# E.ON Whitehill Gas Storage Project

ES FID 2011 Scoping Report

E.ON Whitehill Gas Storage  
Project:  
ES FID 2011 Scoping Report

Reference 0136457

TITLE: **Figure 3.1  
 Indicative Location Plan**

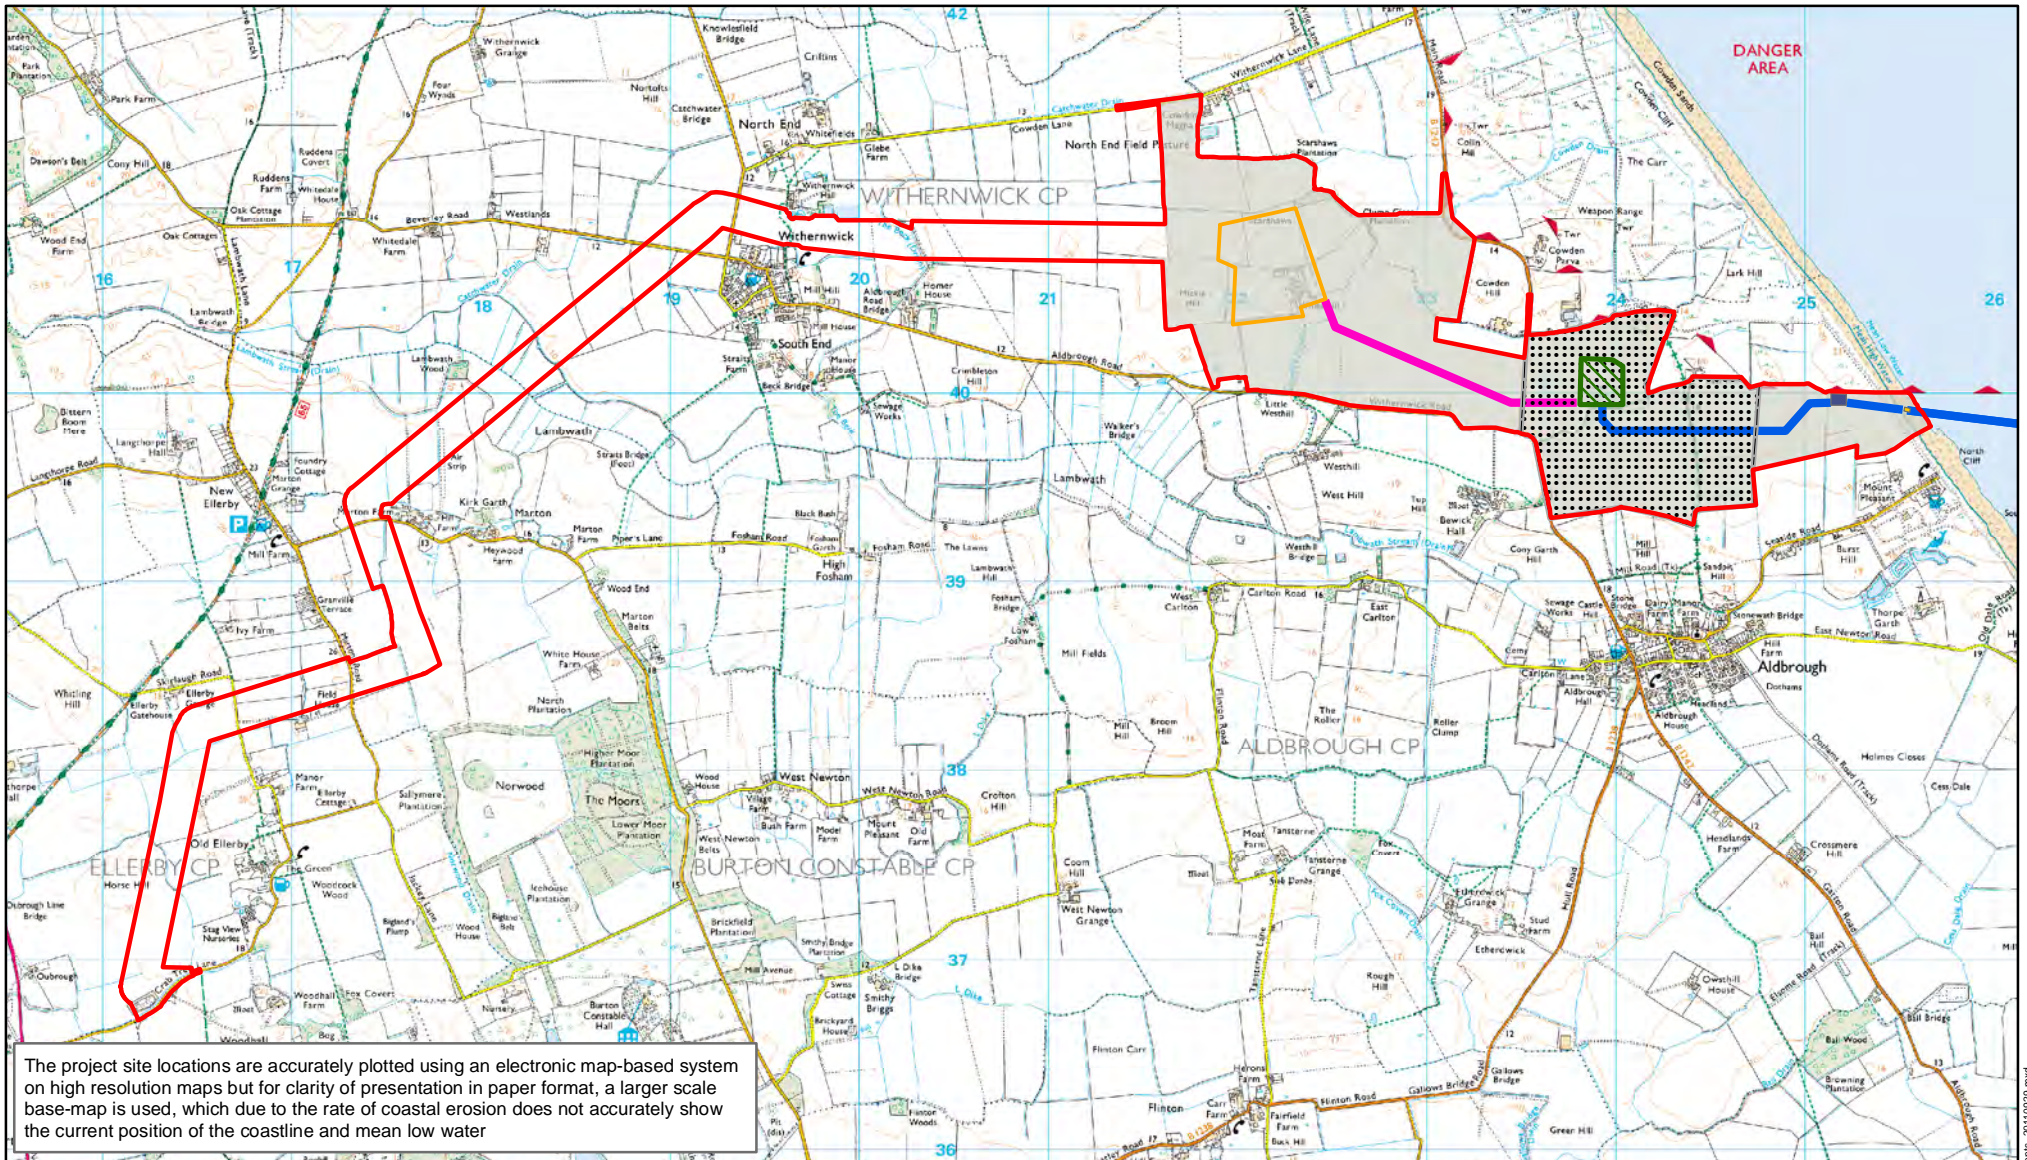
- Instead of a single wellhead compound there will be three.
- Three wellhead compounds will also introduce the need for additional in-field gas, brine discharge and seawater pipelines, data communications infrastructure between the three wellhead compounds and an extension to internal road ways.
- Retention of the solution mining compound to facilitate subsequent well workovers.
- Provision will be made to drill up to 12 wells to provide assurance that if difficulties are encountered and a well cannot be completed, the target of 10 operational wells (and caverns) can still be achieved
- The positions and heights of some of the plant within the GPP site may change.

The proposed increase in the number of wellhead compounds and associated interconnecting pipelines as set out in *Table 3.1* will probably extend the construction schedule set out in the ES FID 2010 (which predicted 6 months to construct the wellhead compound and associated pipelines) by approximately six further months, a total of 1 year. The longer construction programme will result in traffic movements over an increased period, however the peak flows are expected to be unchanged from those set out in the ES FID 2010.

At present there is an 'envelope' of land (see *Figure 3.1*) within which all the wellhead compound development activity will take place. In the first instance
